Backfeed v230

Info (not part of baseline)

Changelog:

Figure 145–29a — Reflected voltage requirements

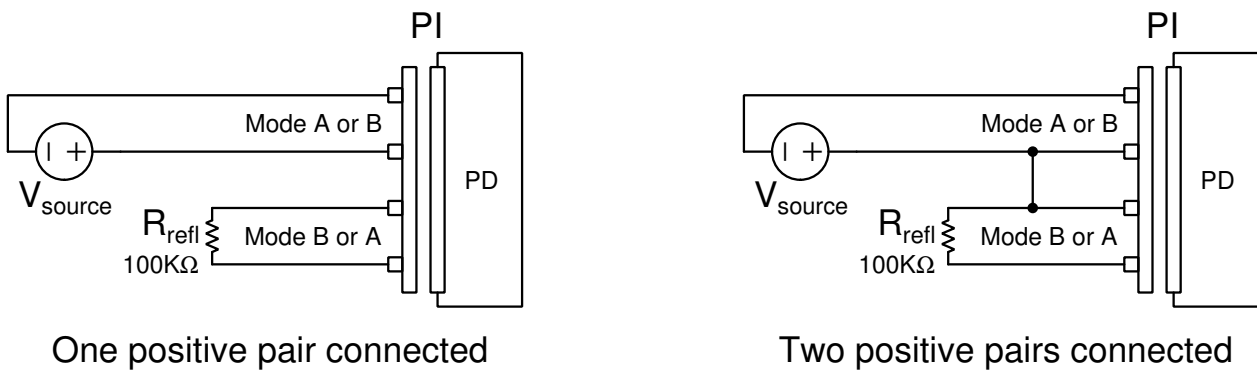
145.3.8.8 ~~Backfeed~~ Reflected voltage

Replace the contents of 145.3.8.8 as follows:

For a single-signature PD, when any voltage in the range of 0 V to $V_{Port_PD-2P\ max}$ is applied per any of the valid 2-pair configurations, defined in Table 145–20, that have only a single pair connected to positive V_{PSE} (see Figure 145–29a), the voltage on the Mode not connected to the voltage source, with a 100 k Ω resistor connected across that Mode, shall not exceed V_{refl} as defined in Table 145–29.

For a single-signature PD, when any voltage in the range of 0 V to 10.1 V is applied per any of the valid 2-pair configurations, defined in Table 145–20, including those with two pairs connected to positive V_{PSE} (see Figure 145–29a), the voltage on the Mode with at least one pair not connected to the voltage source, with a 100 k Ω resistor connected across that Mode, shall not exceed V_{refl} as defined in Table 145–29. This requirement does not apply if a voltage greater than 10.1 V has been applied on either Mode until the voltage on both Modes has been less than V_{Reset} for at least T_{Reset} .

For a dual-signature PD, when any voltage in the range of 0 V to $V_{Port_PD-2P\ max}$ is applied per any of the valid 2-pair configurations, defined in Table 145–20, including those with two pairs connected to positive V_{PSE} (see Figure 145–29a), the voltage on the Mode with at least one pair not connected to the voltage source, with a 100 k Ω resistor connected across that Mode, shall not exceed V_{refl} as defined in Table 145–29.
